ATTACHMENT 2 TO AEP:NRC:1129M

HEJ SLEEVED TUBE STRUCTURAL INTEGRITY LIMITS

DONALD C. COOK NUCLEAR PLANT UNIT 1

MARKED UP VERSION OF CURRENT TECHNICAL SPECIFICATION PAGES

FIGURE B 3/4.4.5-1
Application of HEJ sleeved tube plugging limits

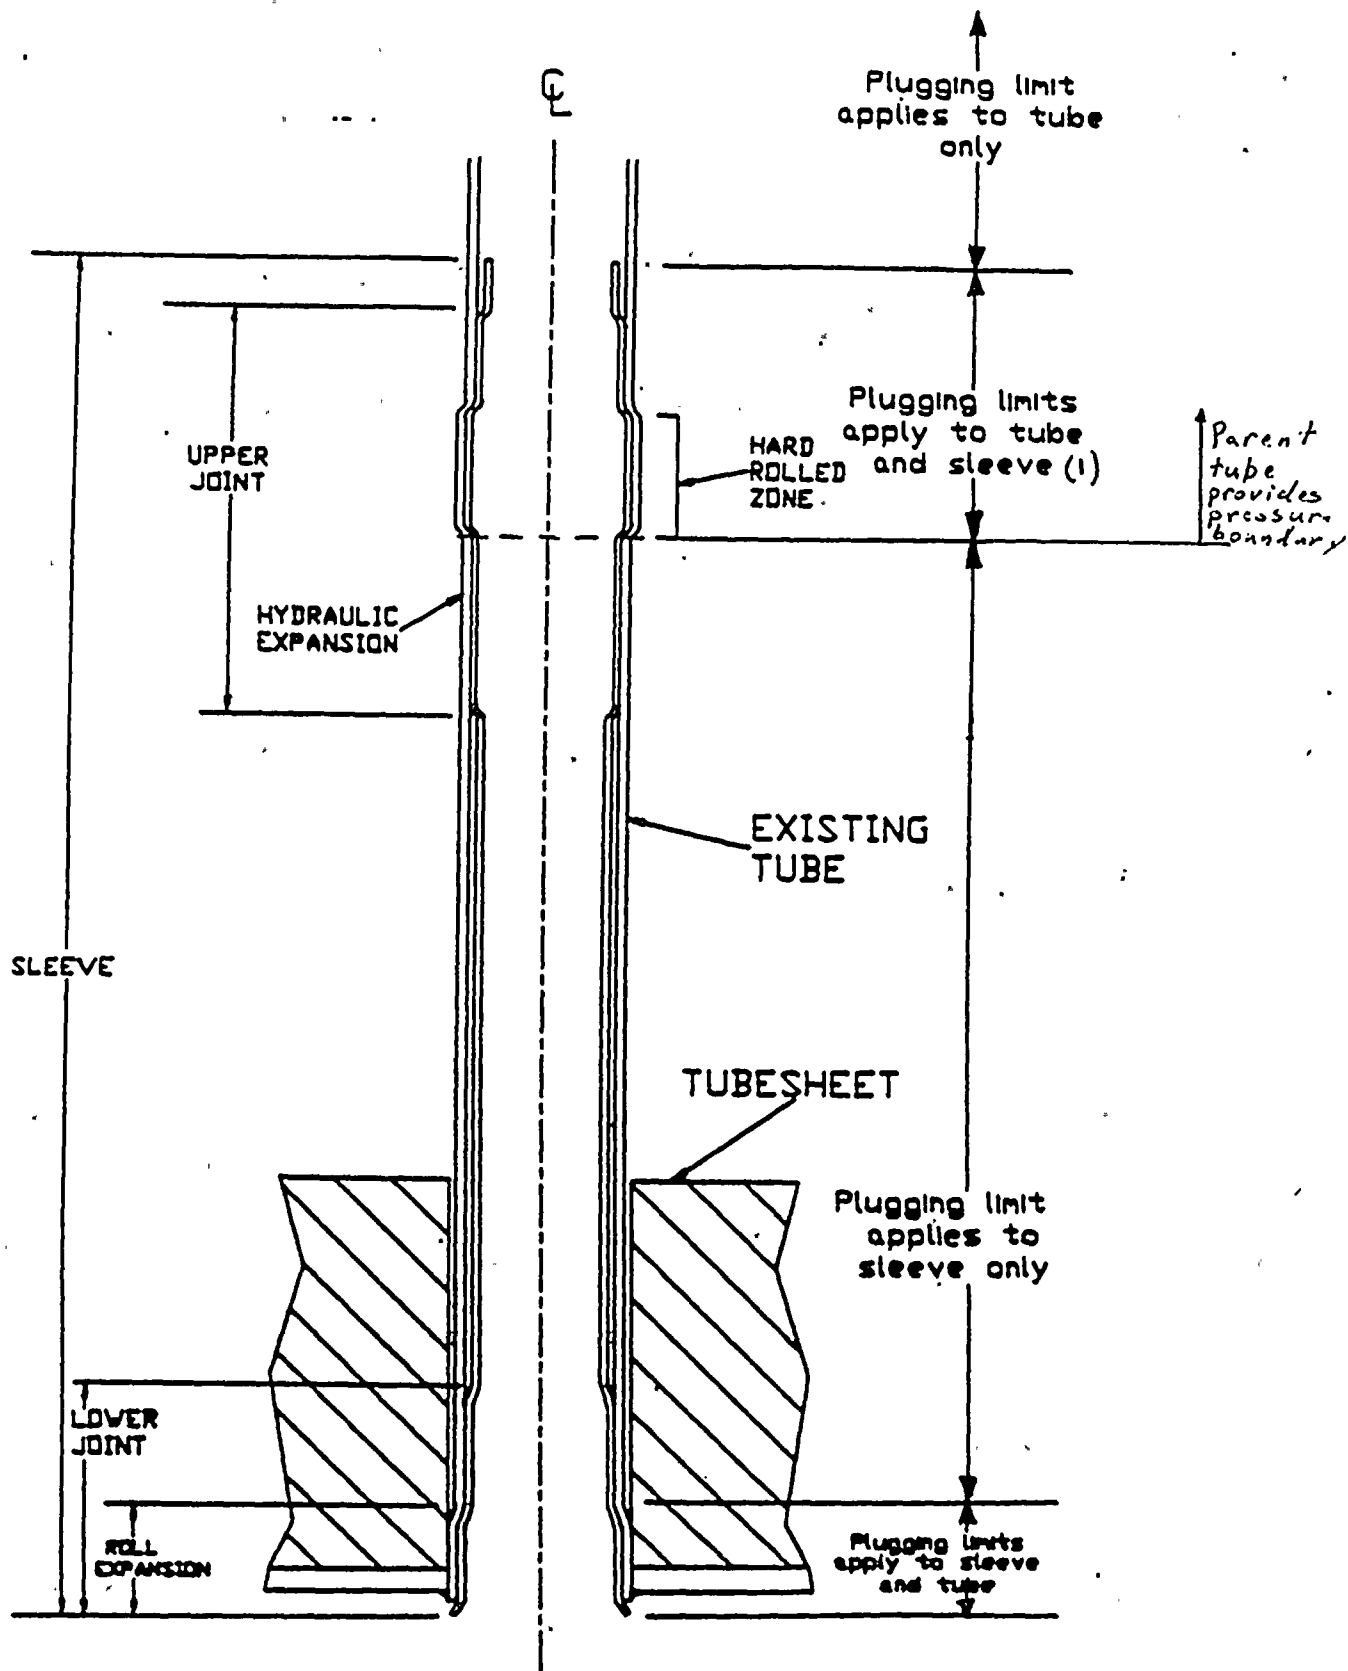
INSERT
FIGURE B 3/4.4.5

Inspection experience at other plants with HEJ sleeved tubes has indicated that a potential exists for the sleeved tube to develop primarily circumferentially oriented degradation in the upper HEJ hardroll lower transition region. The pressure boundary for HEJ sleeves is shown on Figure B 3/4.4.5-1. The pressure boundary used to disposition parent tube indications (PTIs) detected in the upper joint of HEJ sleeved tubes is discussed in WCAP-14641, "HEJ Sleeved Tube Structural Integrity Criteria: ΔD Diametral Interference at PTIs," April 1996. The pressure boundary will allow PTIs located such that there is a minimum diameter change of 0.003" (plus an allowance for NDE uncertainty) between the peak diameter of the sleeve hardroll, and the diameter at the elevation of the PTI, to remain in service. The 0.003" interference lip is derived from structural and leakage testing. When inspecting and dispositioning the PTIs, the acceptance criterion will be adjusted to account for measurement uncertainties associated with the technique used to measure the relative change in ID sleeve diameters. During field application, the PTI elevation will be measured by comparing the diameter reported at the peak amplitude of the flaw, and the diameter at the center of the coil's field, and using the more conservative of the two diameters to perform the Delta-D determination. Application of the pressure boundary for HEJ sleeved tubes provides allowance for leakage in a faulted loop during a postulated steam line break (SLB) event. A SLB leakage of 0.025 gpm is assumed for each applicable indication. Steam line break leakage from all sources must be calculated to be < 8.4 gpm in the faulted loop. Maintenance of the 8.4 gpm limit ensures off-site doses will remain within a small fraction of the 10 CFR Part 100 guideline for a SLB.

- c. HEJ sleeved tubes with axial indications located within the parent tube pressure boundary as defined on Figure B 3/4.4.5-1 shall be plugged or repaired prior to returning the steam generators to service.

- d. HEJ sleeved tubes with parent tube indications located outside of the parent tube pressure boundary (below the upper hardroll region) as defined on Figure B 3/4.4.5-1 may remain in service.

Figure B 3/4.4.5-1
Application of HEJ Sleeved Tube Plugging Limits

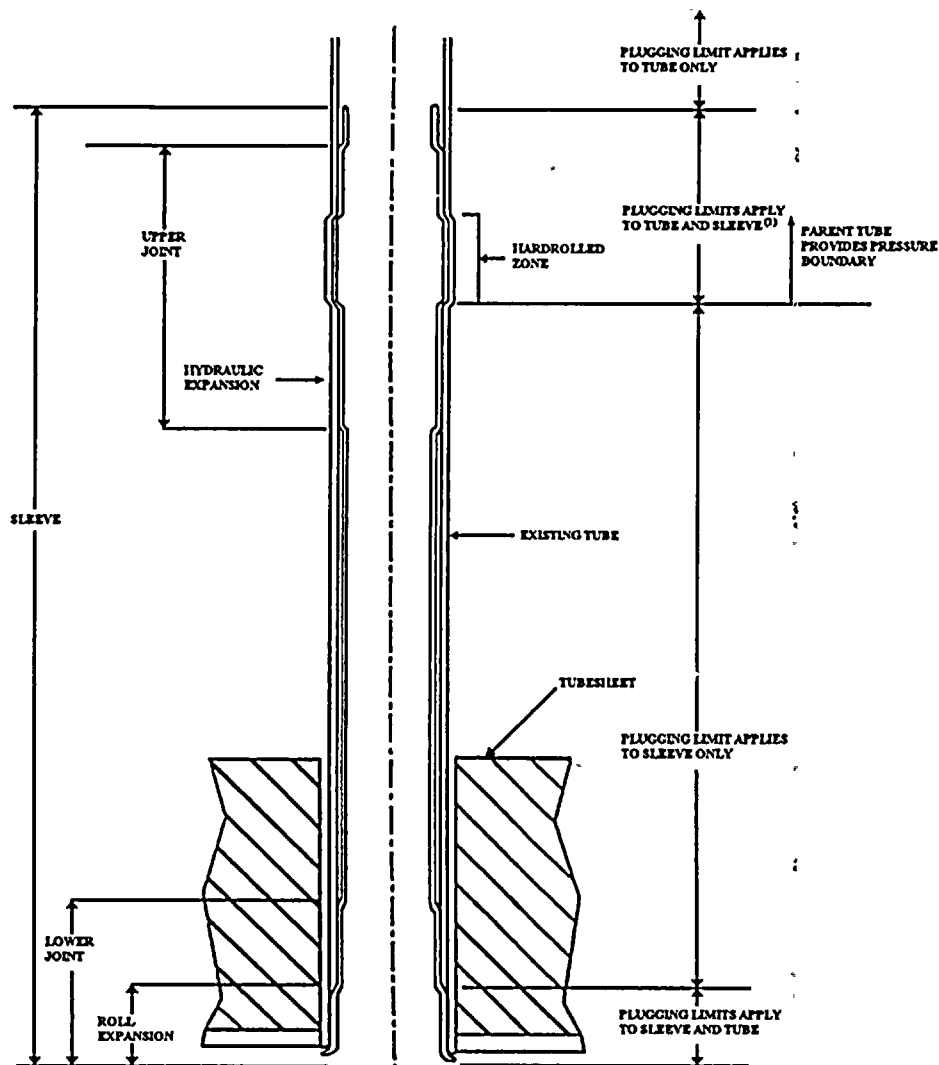
Inspection experience at other plants with HEJ sleeved tubes has indicated that a potential exists for the sleeved tube to develop primarily circumferentially oriented degradation in the upper HEJ hardroll lower transition region. The pressure boundary for HEJ sleeves is shown on Figure B 3/4.4.5-1. The pressure boundary used to disposition parent tube indications (PTIs) detected in the upper joint of HEJ sleeved tubes is discussed in WCAP 14641, "HEJ Sleeved Tube Structural Integrity Criteria: 'ΔD' Diametral Interference at PTIs," April 1996. The pressure boundary will allow PTIs located such that there is a minimum diameter change of 0.003" (plus an allowance for NDE uncertainty) between the peak diameter of the sleeve hardroll, and the diameter at the elevation of the PTI, to remain in service. The 0.003" interference lip is derived from structural and leakage testing. When inspecting and dispositioning the PTIs, the acceptance criterion will be adjusted to account for measurement uncertainties associated with the technique used to measure the relative change in ID sleeve diameters. During field application, the PTI elevation will be measured by comparing the diameter reported at the peak amplitude of the flaw, and the diameter at the center of the coil's field, and using the more conservative of the two diameters to perform the Delta-D determination. Application of the pressure boundary for HEJ sleeved tubes provides allowance for leakage in a faulted loop during a postulated steam line break (SLB) event. A SLB leakage of 0.025 gpm is assumed for each applicable indication. Steam line break leakage from all sources must be calculated to be < 8.4 gpm in the faulted loop. Maintenance of the 8.4 gpm limit ensures off-site doses will remain within a small fraction of the 10 CFR Part 100 guideline for a SLB.

- c. HEJ sleeved tubes with axial indications located within the parent tube pressure boundary as defined on Figure B 3/4.4.5-1 shall be plugged or repaired prior to returning the steam generators to service.

- d. HEJ sleeved tubes with parent tube indications located outside of the parent tube pressure boundary (below the upper hardroll region) as defined on Figure B 3/4.4.5-1 may remain in service.
